NSLPP MEETING HELD ON 03/05/2023

ADDRESS/WARD: 50 Blues Point Road, McMahons Point

APPLICATION No: DA296/22

PROPOSAL: Alterations and additions to an existing semi-detached dwelling

Figure 6: East (street/front) elevation

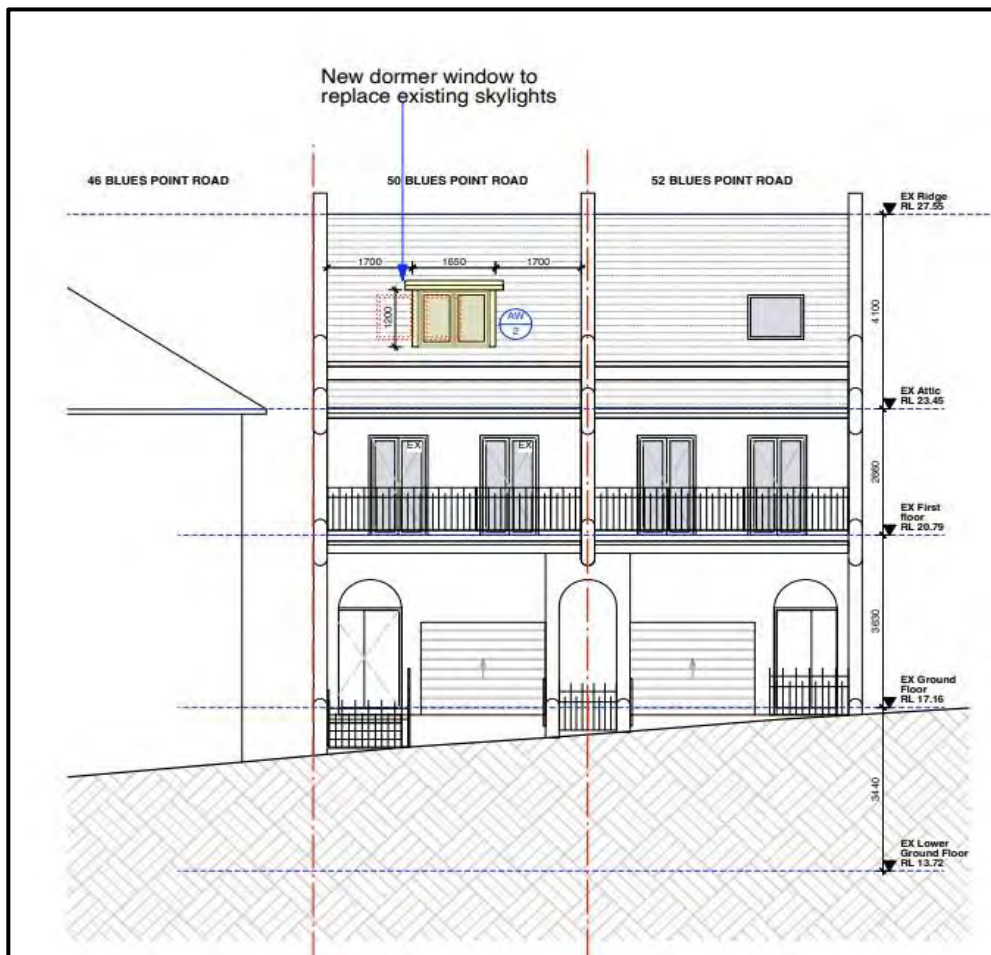
The placement of a dormer on the street facing elevation is not supported. The proposed rear dormer can be supported subject to ensuring its width remains within one third of the width of the roof plane within which it is to be inserted.

The proposed front dormer (as amended) is not supported and design change conditions are imposed to delete this component. Standard heritage conditions will be included, should consent be granted.

Having regard for the context of the site and the applicable environmental planning controls the proposed development will generally deliver an appropriately balanced and responsive planning and design outcome that enables a renovation and minor extension of the semi-detached dwelling, whilst not generating significant and adverse impacts upon the environment, neighbouring properties and the community. The assessment of the proposed development has considered the concerns raised in the submissions as well as the performance of the application against Council's planning requirements. Following this assessment, and having regard to the provisions of Section 4.15 of the *Environmental Planning and Assessment Act 1979* (as amended), the application is recommended for approval, with conditions to delete the front dormer element.

Figure 29: Southern elevation of proposal with non-compliant portions shown in green (existing building) and orange (proposed additions).

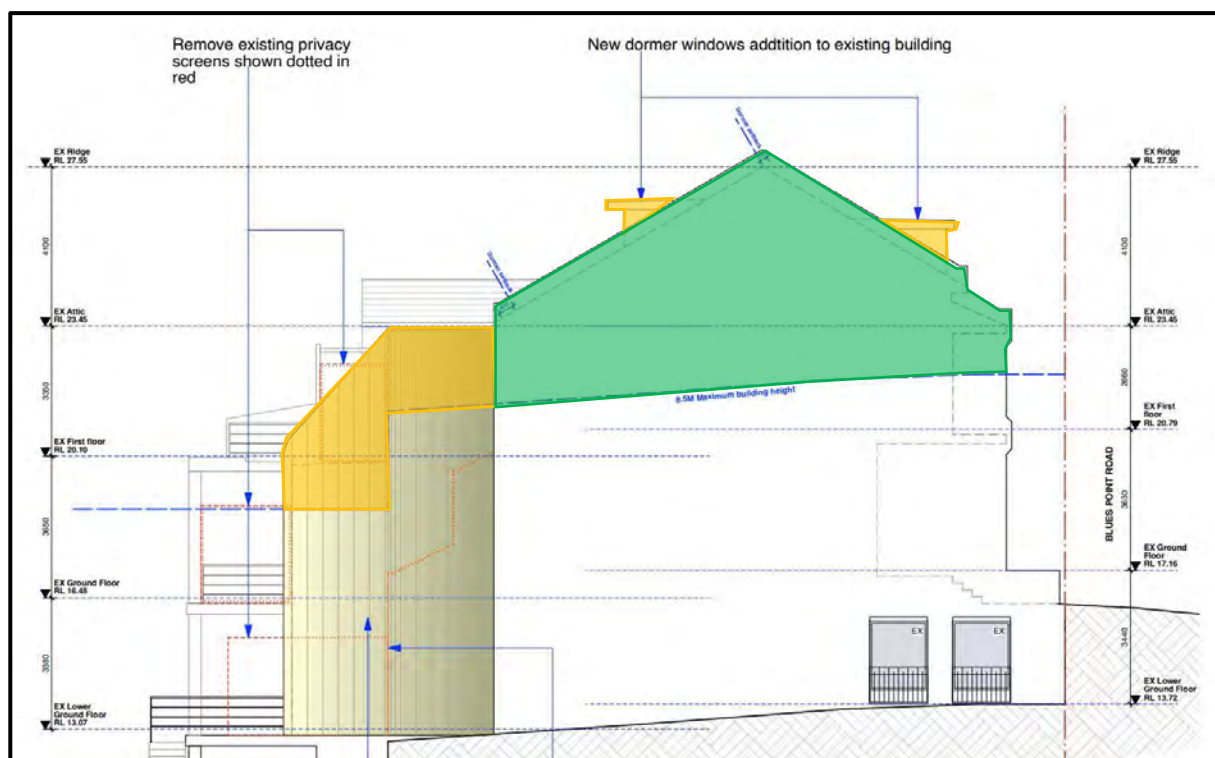
As described above, the proposed development involves a maximum height of 12.98m (for the rear dormer), which represents a 3.98m or 46.8% variation to the maximum height of buildings development standard. It is noted that the entire first floor and attic level and upper roof above the attic/first floor of the semi-detached residence do not comply with the maximum height of buildings provision under Clause 4.3 (refer to Figure 29).
